DATE: 04.18.2018
TO: ProTrak
FROM: Mitesh Baxi
Traffic Engineering

■ **SUMMERLIN PLACE [Subdivision Plan Review]**

↻ Initial Review Note ↻

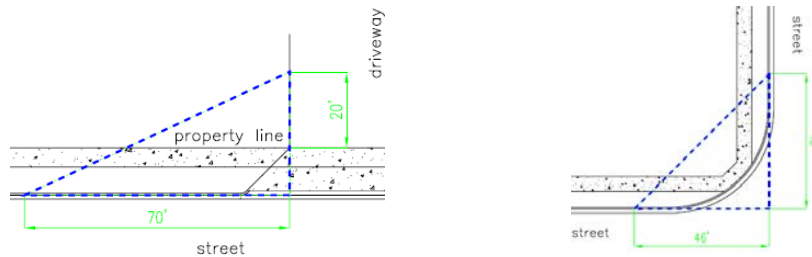
1. Install wheelchair ramp at intersection of proposed street Summerlin Dr and Wrightsville Ave as per NCDOT and/or City standards [SD 3-09 of CofWTSSM](#). Connect sidewalk with ramp.
2. The minimum street corner radii is 35'. [\[7-5 CofW Tech Stds\]](#)
3. Provide the detail of the Cul-de-sac of Summerlin Dr. Detail should include the proposed design of the type of whether it will be a driveway or a street type connection.
4. Please show all the traffic control devices and pavement marking showing the traffic flow for this project.

SUMMERLIN PLACE STANDARD STREET LIGHT PLAN

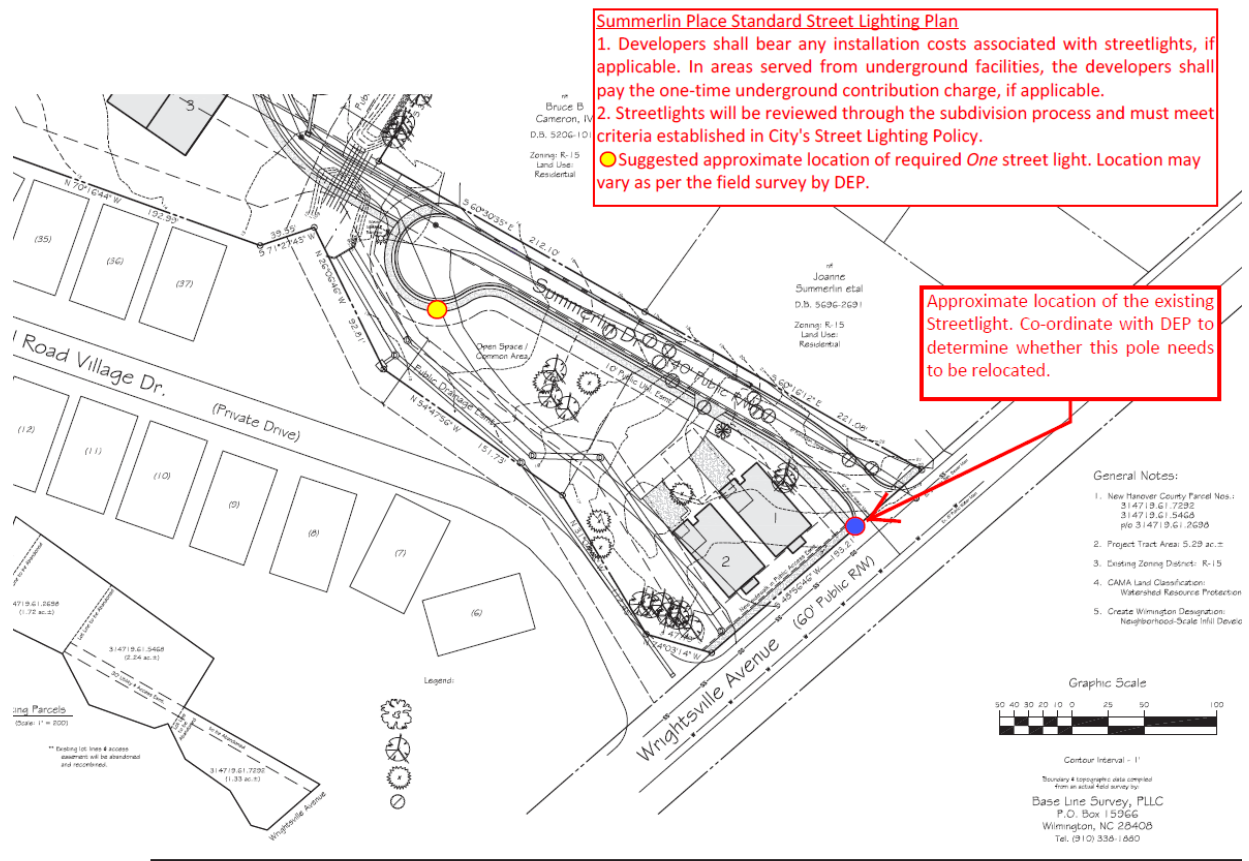
- A layout for the Standard street lighting has been provided with the review. Considering an existing street light at the corner of proposed Summerlin Dr and Wrightsville Ave, additionally one street light will be required for proposed length of the Summerlin Dr cul-de-sac. Although, developers may choose to provide any extra lights or ornamental. Any installations above the criteria of Standard street lighting, will be considered as non-standard and has to conform to the City's non-standard street lighting procedure as per the policy.
